CITY OF ALBUQUERQUE

**RE: Audi Porsche of Albuquerque
8920 Pan American Freeway NE
Grading & Drainage Plan
Engineer's Stamp Date: 10/24/22
Hydrology File: C18D062**

**WAIVER APPLICATION FROM STORMWATER
QUALITY VOLUME MANAGEMENT ON-SITE**

SHEET NO.
C-200

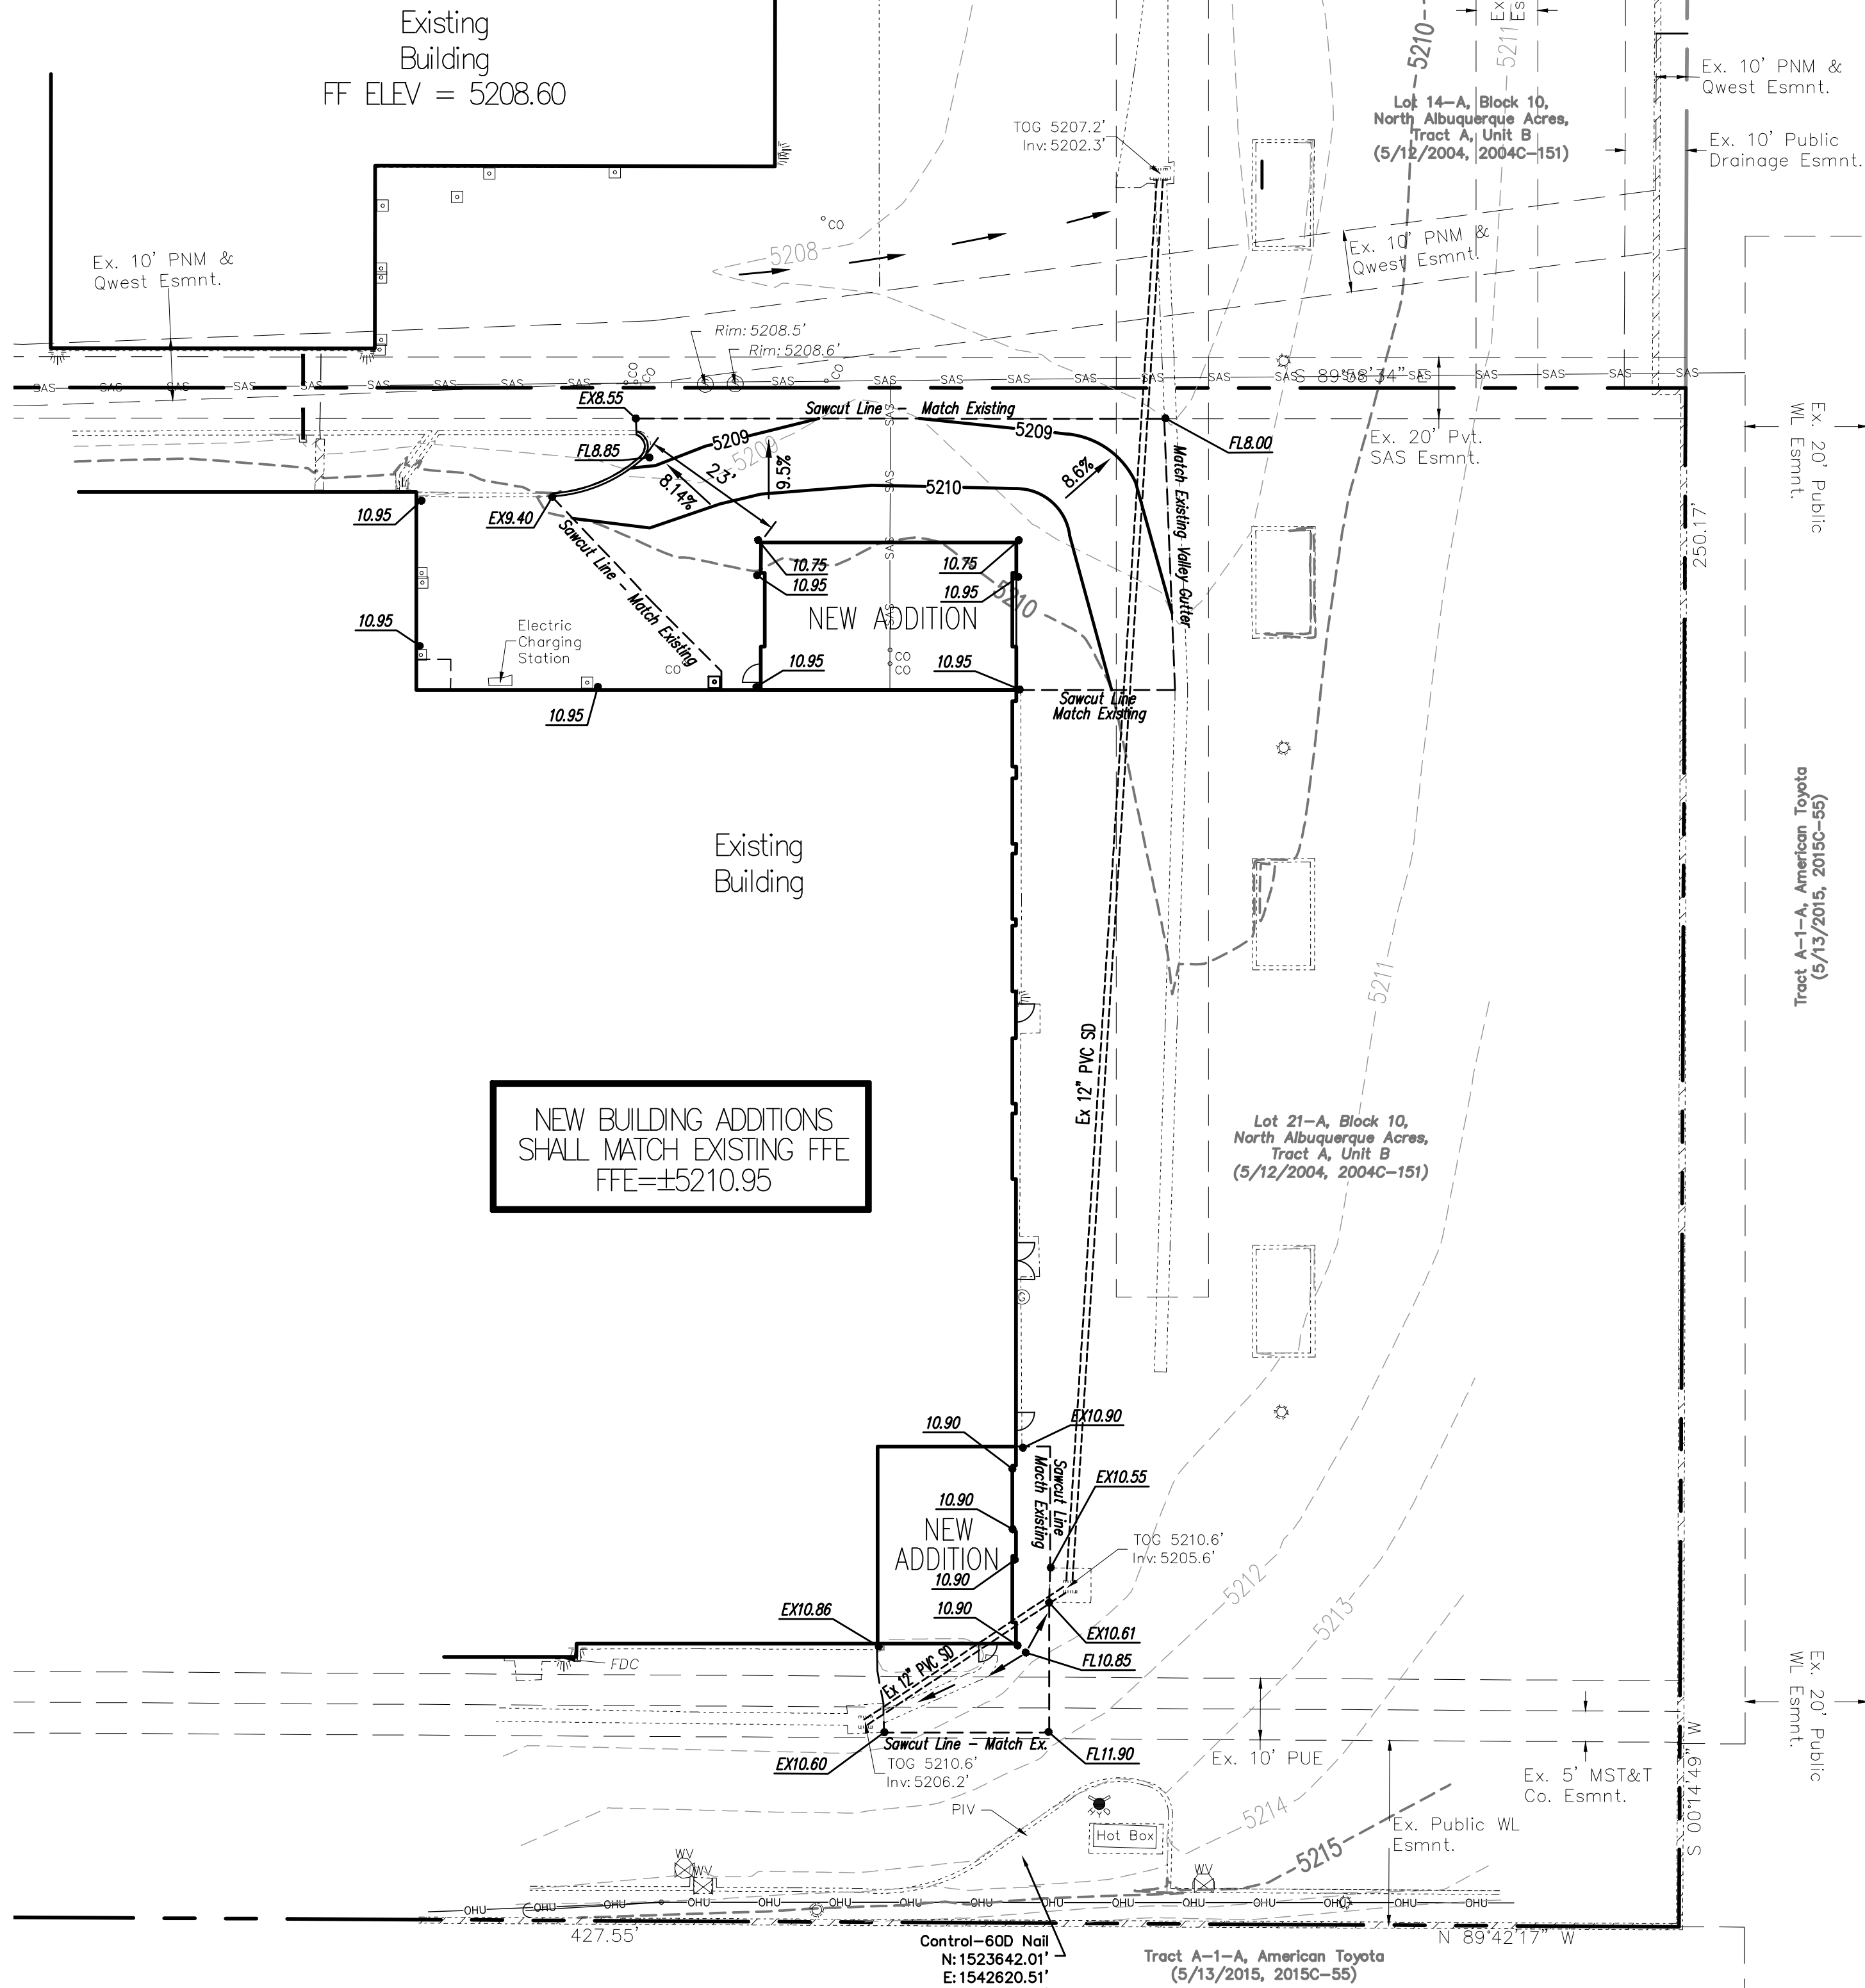
Based upon the information provided in your submittal received 11/21/2022, the Grading & Drainage Plan is approved for Building Permit. Please attach a copy of this approved plan in the construction sets for Building Permit processing along with a copy of this letter.

1. Engineer's Certification, per the DPM Part 6-14 (F): *Engineer's Certification Checklist For Non-Subdivision* is required.
2. Please pay the Payment-in-Lieu of \$ **880.00** by emailing the attached approved Waiver Application from Stormwater Quality Volume Management On-site to PLNDRS@cabq.gov. Once this is received, a receipt will then produce and email back with instructions on how to pay online. Once paid, please email me proof of payment.
